Service Bulletin

Bulletin No.: 20-NA-040

Subject: Pickup Box Power Endgate May Not Open on Initial Press, or May Not Open at All

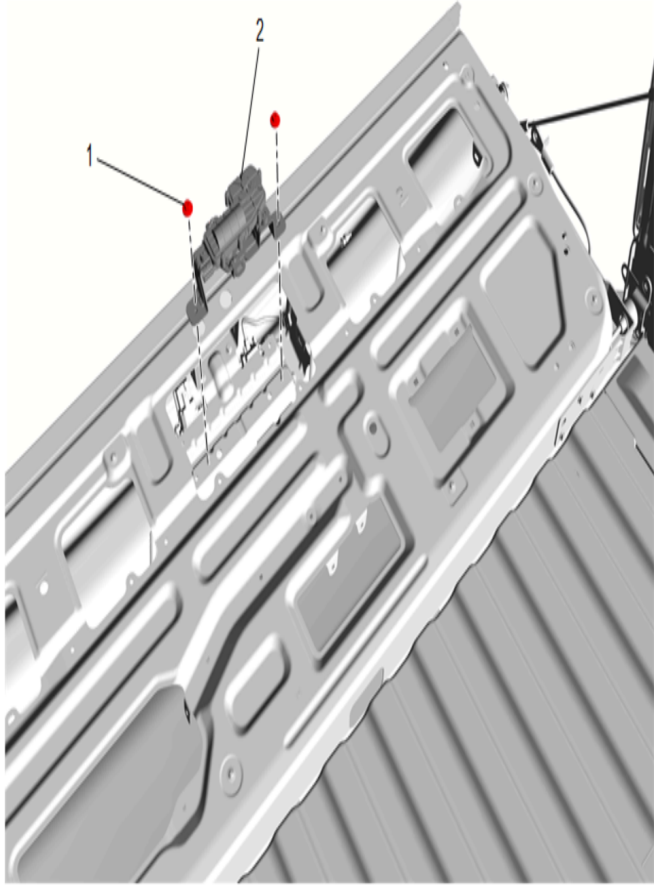
Involved Region or Country	North America, Europe, Russia, Middle East, Israel, Palestine, South America, Philippines, Australia, New Zealand, Egypt, Africa, South Africa
Additional Options (RPOs)	Equipped with QK1 and QT5
Condition	Some customers may comment on the power endgate may not unlatch or drop on first try, or under some conditions, it may not open at all.
Cause	The cause of the condition may be a combination of excessive spring force and low available voltage, which may cause the latch actuator to fail to function.
Preliminary Procedure	<p>Some vehicles, which have a tonneau cover installed, may be affected by a similar Condition, however the Cause and Correction are completely different from this bulletin. On these vehicles, it will be necessary rule out the tonneau cover as the possible Cause of the condition:</p> <ol style="list-style-type: none"> 1. Open the rear end panel of the tonneau cover. 2. Cycle the power tailgate 5 times using push button activation for auto open and close manually. <ul style="list-style-type: none"> • If the power endgate Does function properly, DO NOT proceed with this bulletin repair, but move on to Bulletin # 20-NA-044 and complete the tonneau adjustment procedure. • If the power endgate still DOES NOT function properly, continue on and complete the Correction outlined in this bulletin.

<p>Correction</p>	 <p style="text-align: right; font-size: small;">5049815</p> <p>Upon verifying the condition, replace the pickup box endgate lock actuator (2) with an improved design service part. Refer to <i>Pickup Box Endgate Lock Actuator Replacement (Power)</i> in SI.</p>
--------------------------	---
